WATER SERVICE PERMIT

FOUNDATION PERMIT

: TB-22-1365
E.S. Farland Circle
Assessors Map 130D, Lot: 482
Permit Type: foundation for 1-2 Family
Reviewed: 6-24-2022 by S.Crampton

SITE PLAN
— FARLAND CIRCLE —
ASSESSORS MAP 130D LOT 482
NEW BEDFORD, MASSACHUSETTS

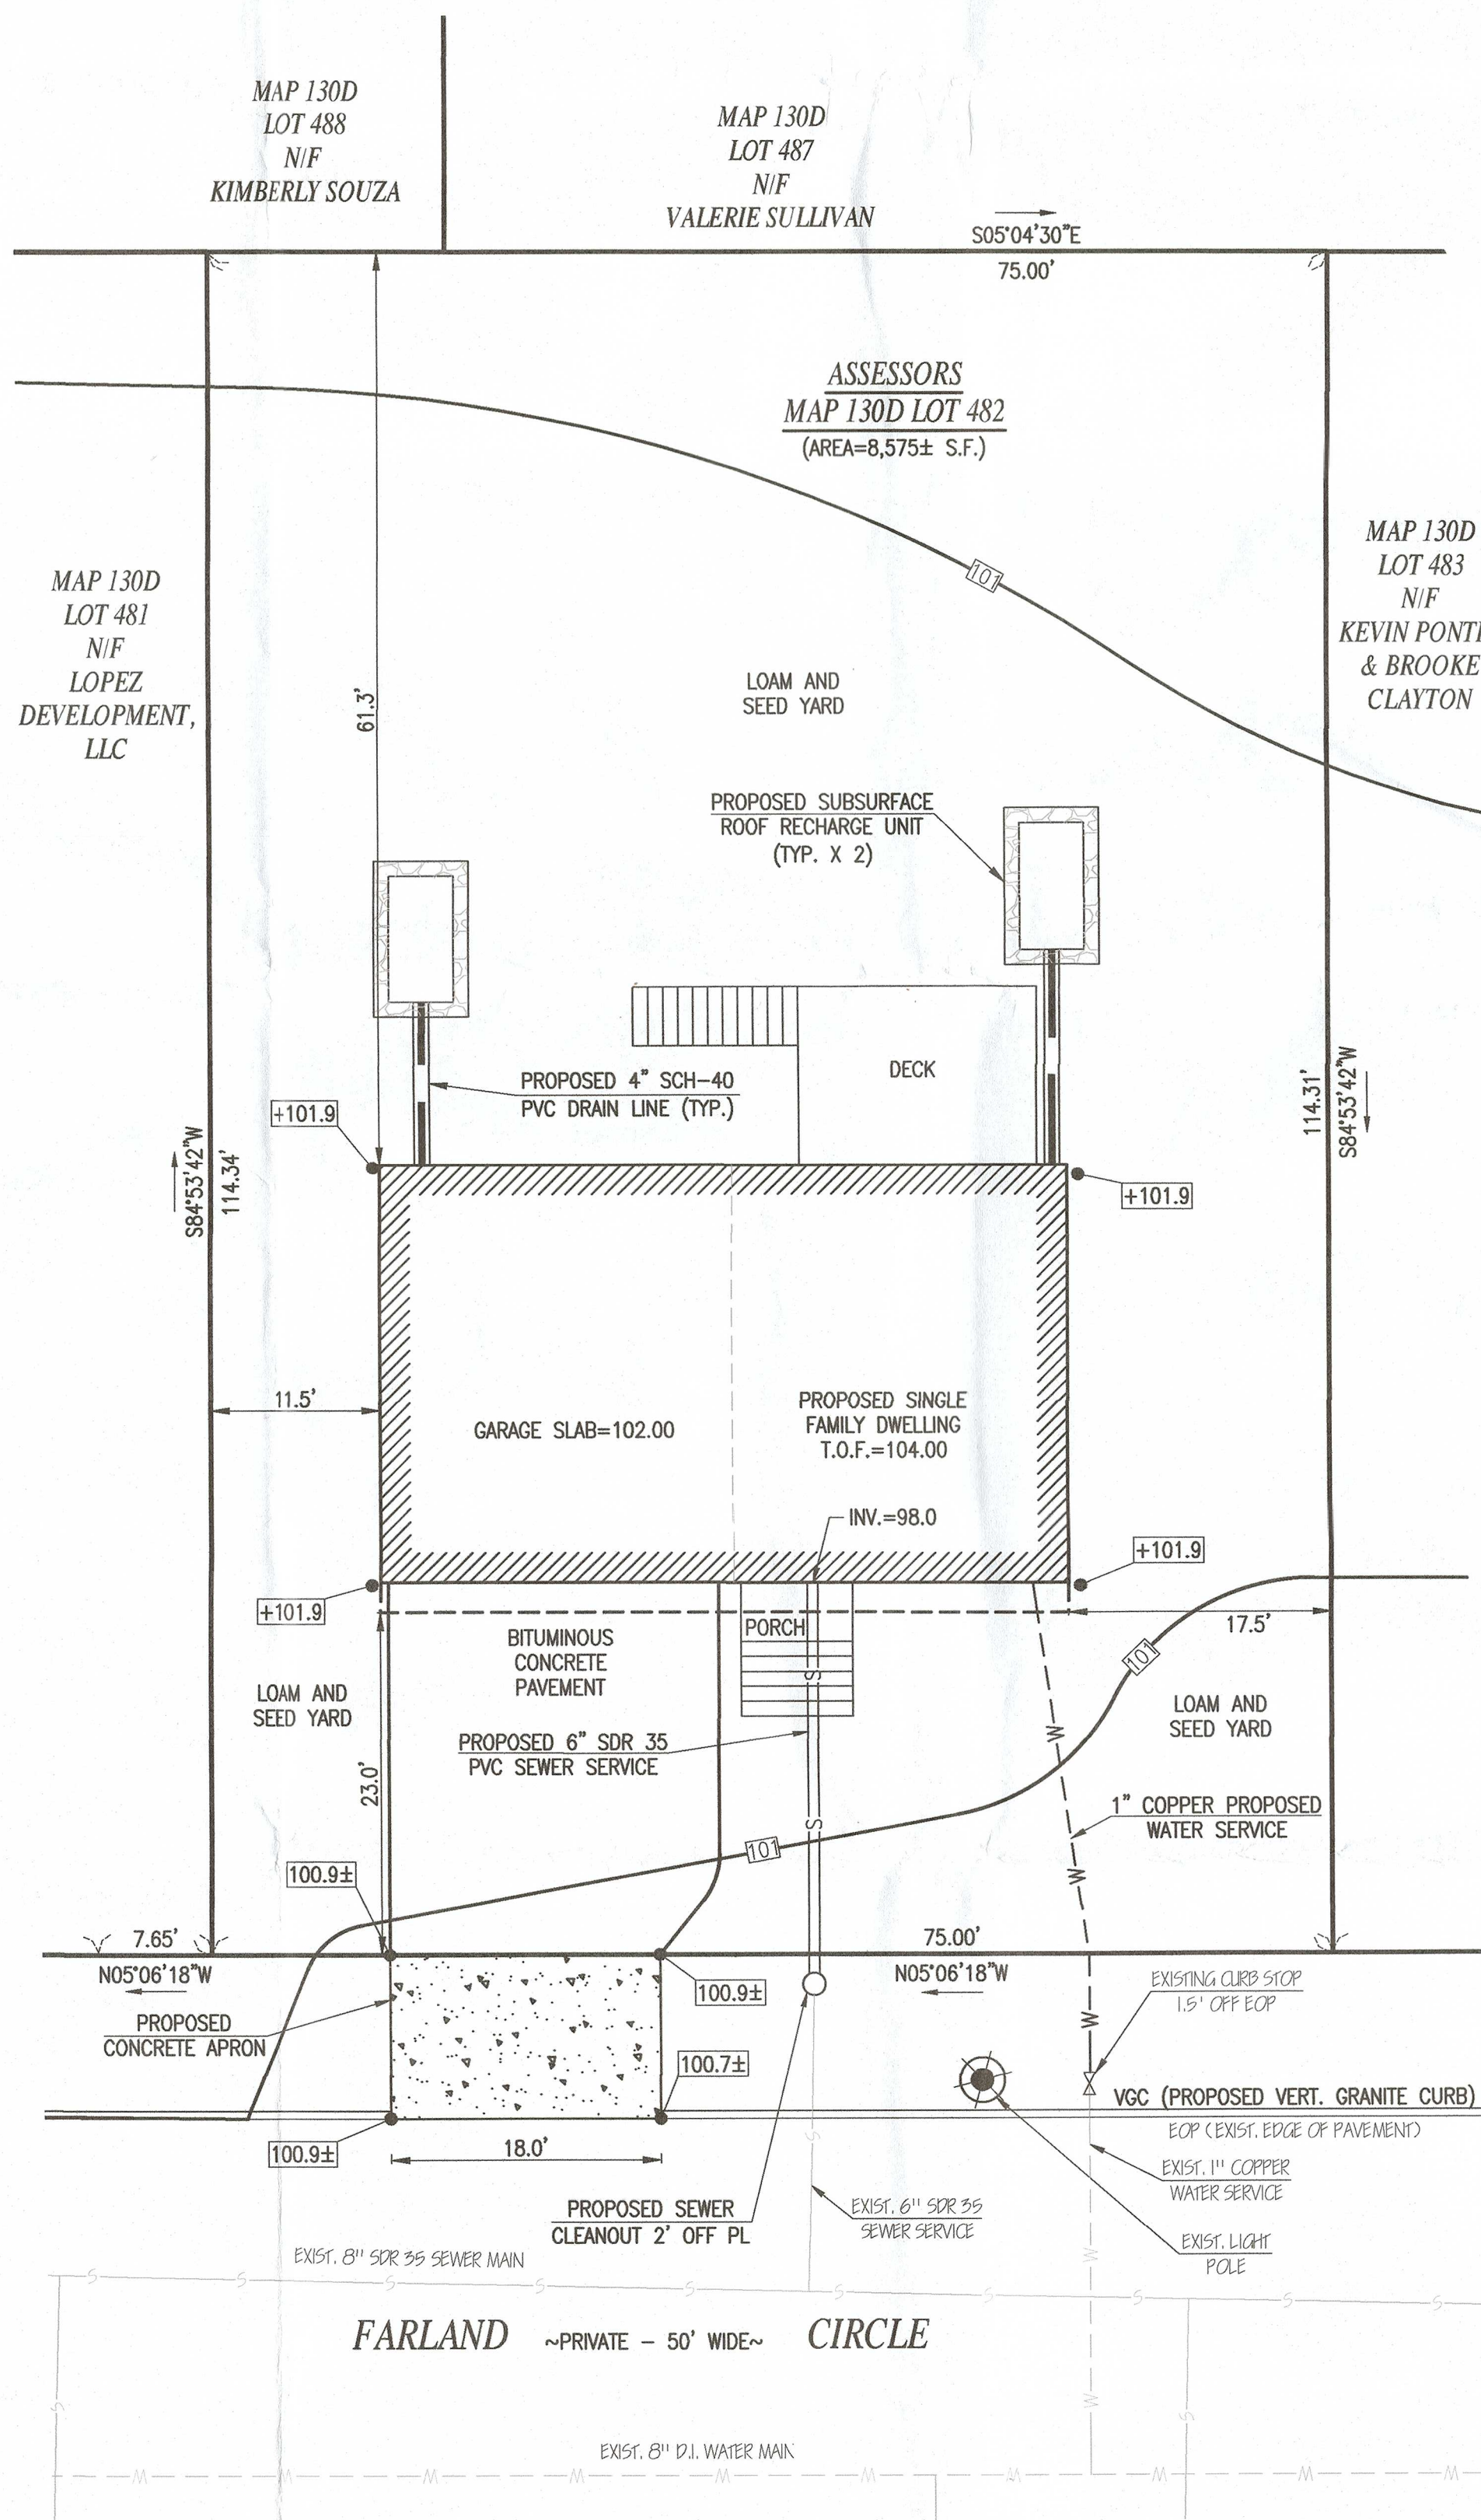
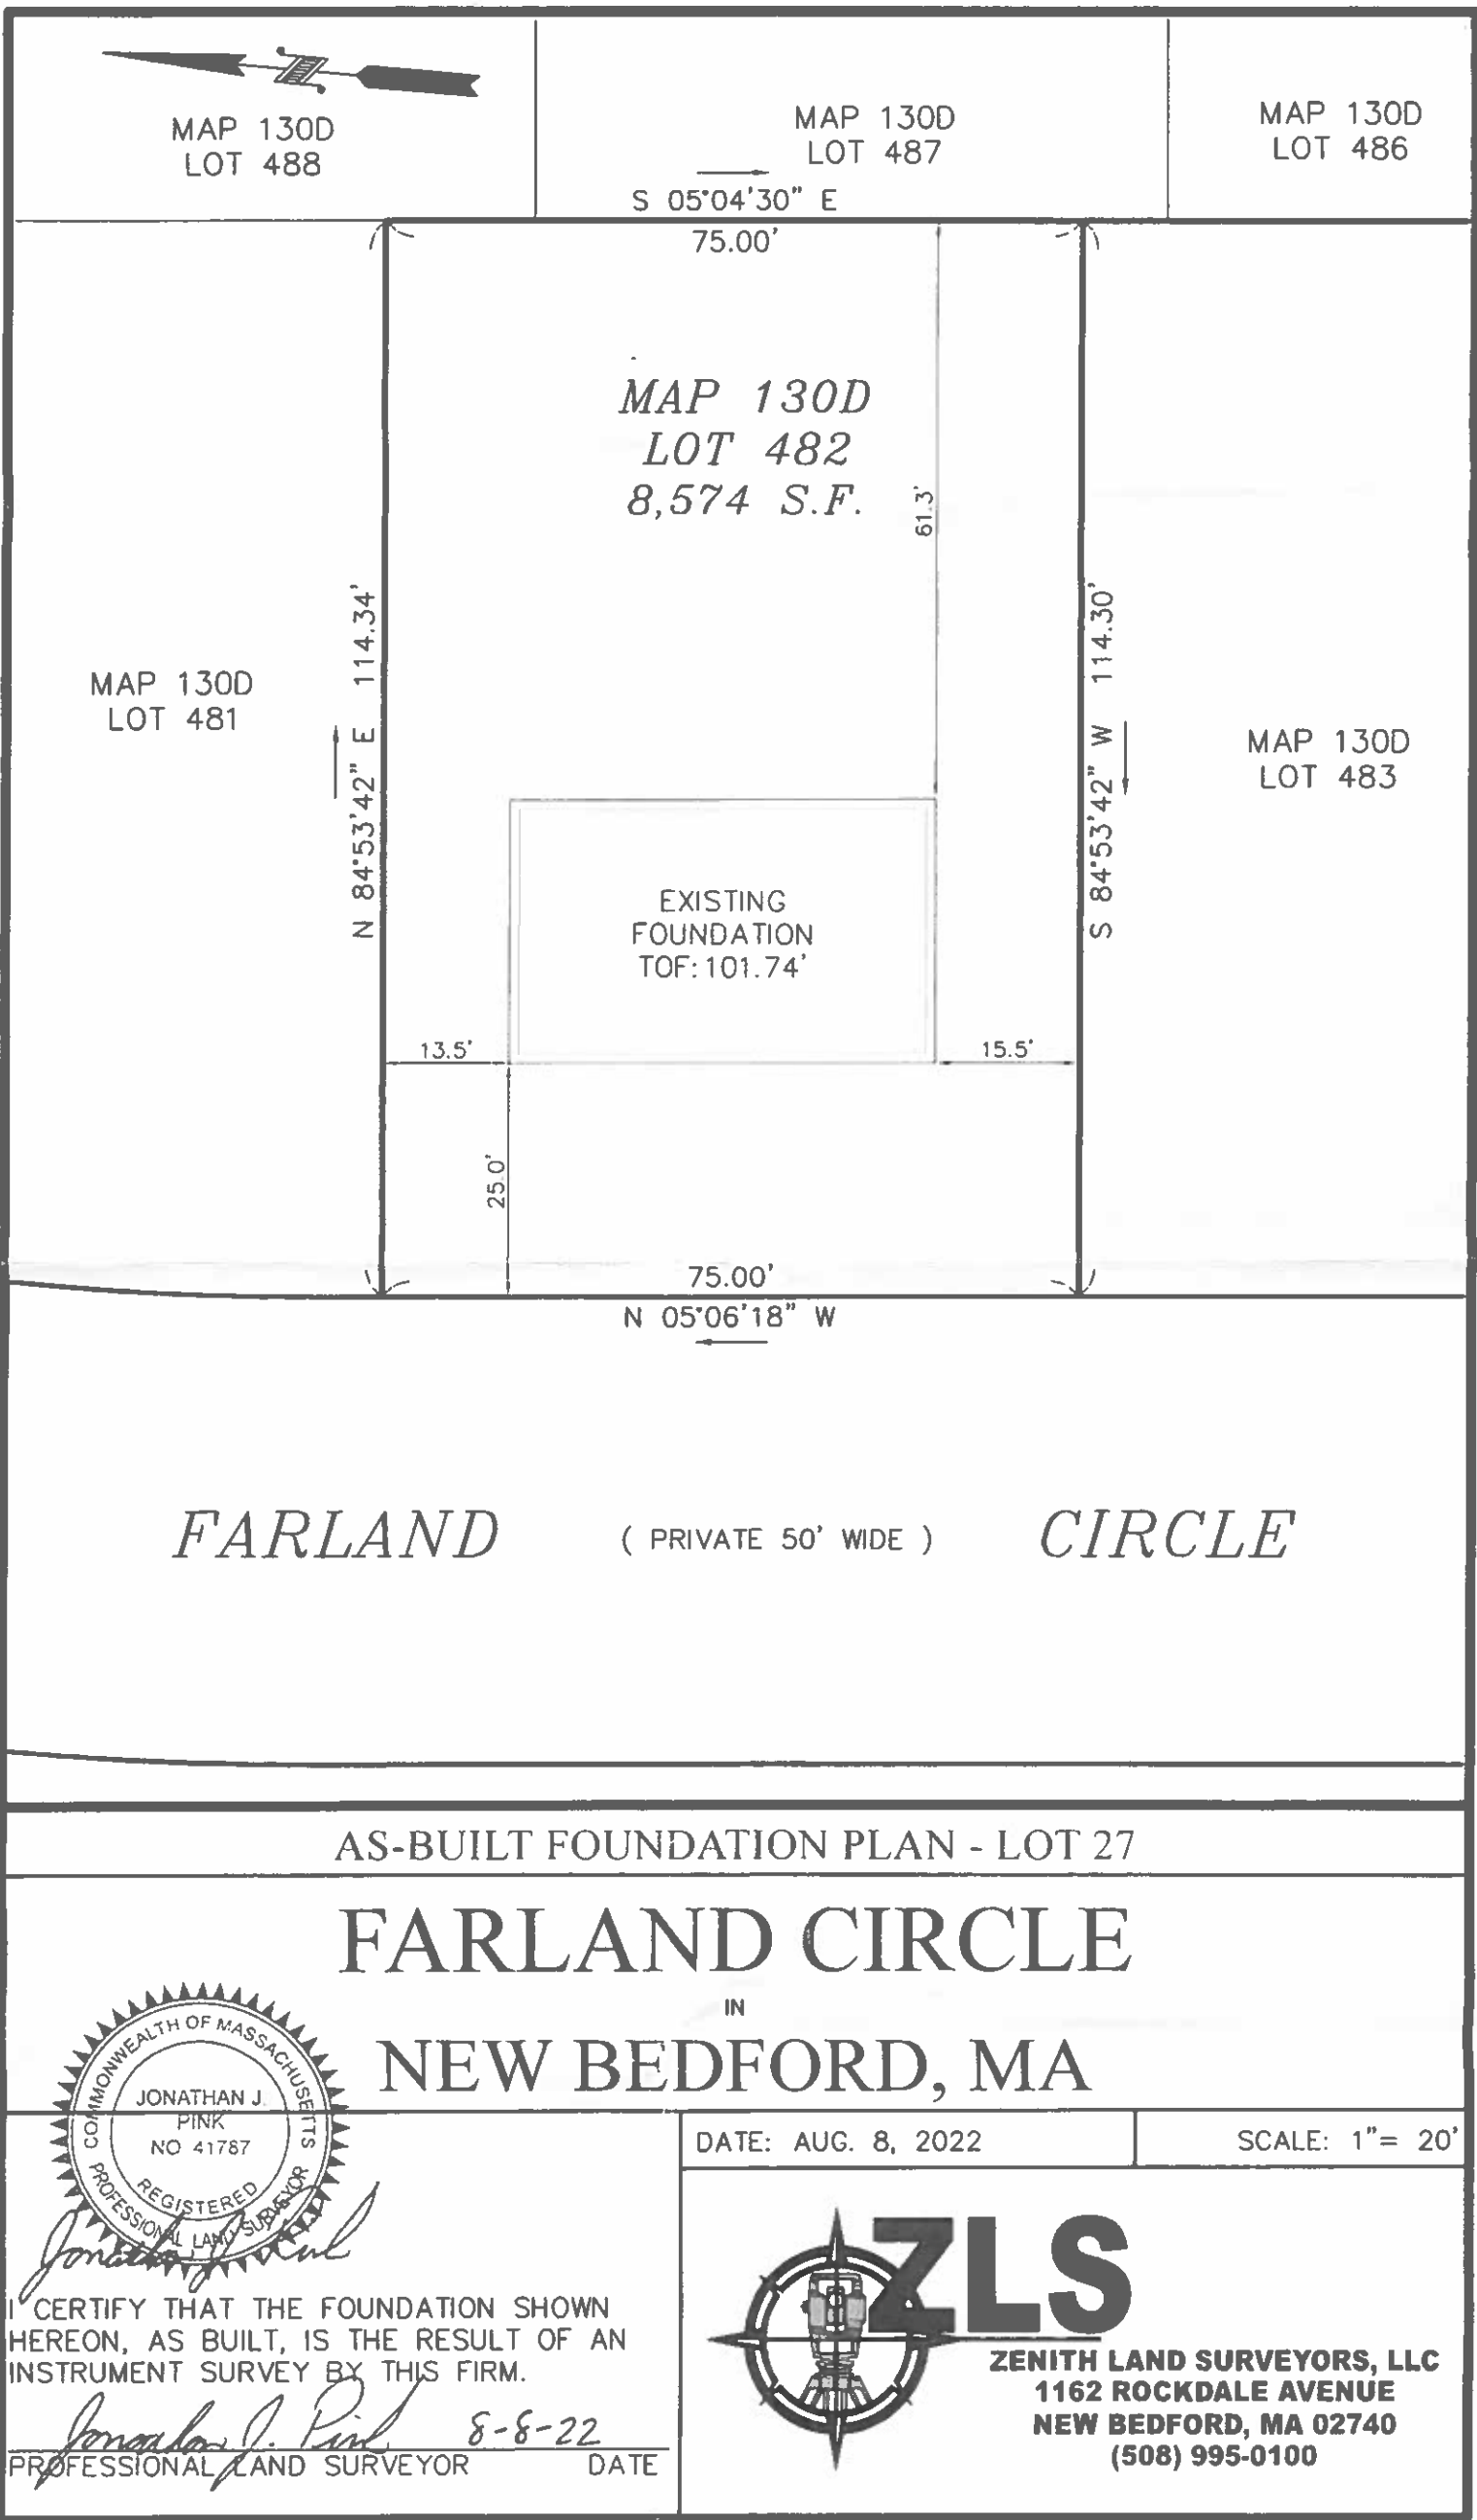
Site plan submitted via email on 6-15-2022 (dated June 25, 2020) has been reviewed and Conditionally Approved by DPI with the following comments:

1. Engineer to revise site plan, per comments listed below:
 - a) Label of existing "water gate" for service tie-in to be labeled as "curb stop"
 - b) Provide topography/elevations for the backyard

- c) Bearing for the easterly lot line is incorrect. Bearing labeled is for lot 487, not 482. Update plan accordingly.
 - d) Add additional labeling to identify loam & seed area, patios, walkways, etc.

- e) Stormwater calculations to revised. Must include all impervious area (foundation footprint, driveway, patios, etc.)
 - f) Record Owner callout at bottom lefthand side of the page is incorrect. Update to current owner on file.

- g) Notes #4 pertaining to sump pump tie in to revised to state the following: " IF SUMP PUMP IS INSTALLED, A CONCRETE LIP MUST BE INSTALLED AROUND THE SUMP PUMP AND A RELEASE OF LIABILITY FORM TO BE FILED WITH THE CITY OF NEW BEDFORD DEPT. OF PUBLIC INFRASTRUCTURE BY THE PROPERTY OWNER."

2. Applicant will not be able to file for DPI permits until revised plans have been submitted and approved by DPI Engineering.
3. Applicant is responsible for providing Inspection Services with the "final" site plan approved by DPI to be placed on file in the View Permit system for record/review by other City departments.
